Interactive comment on “Performance assessment of a triple-frequency spaceborne cloud–precipitation radar concept using a global cloud-resolving model” by J. Leinonen et al.

J. Leinonen et al.

Received and published: 2 July 2015

Fig. 1. A conceptual example of nonuniform beam filling leading to a larger number of detected points.

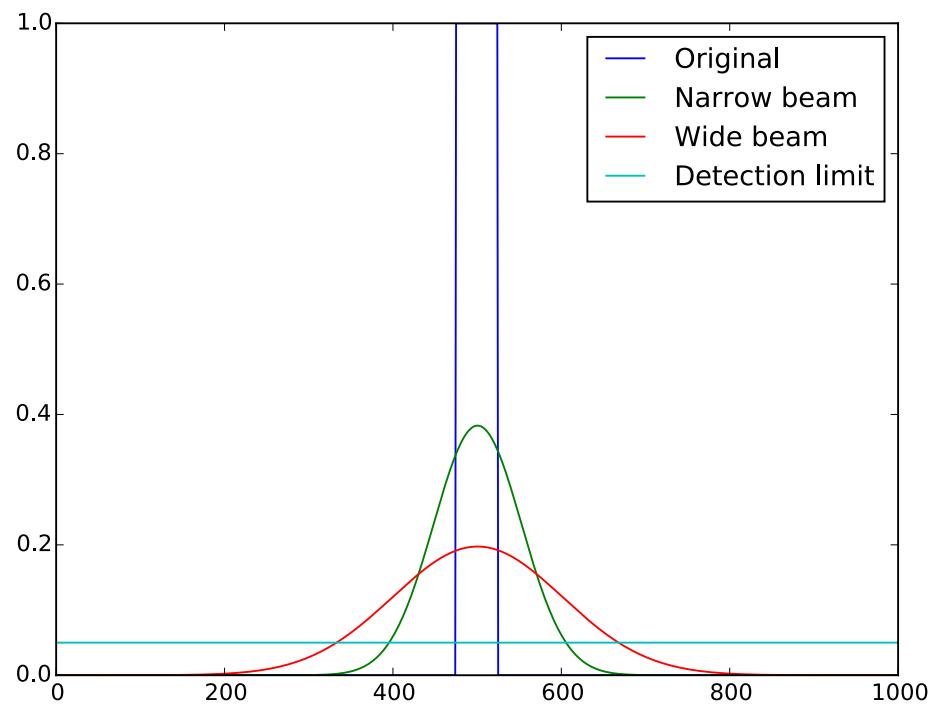
6) Line 22-24 Page 4159 : I can't understand how this is possible.

A conceptual drawing of this effect is given in the attached plot. There, it can be seen that the wider beam results in the signal being detected over a larger area. In the case discussed in Sect. 5.2, the magnitude of this effect is larger than the area-decreasing effect of the loss of sensitivity. More detail was added to the sentence in order make it clearer to the reader why this effect arises.
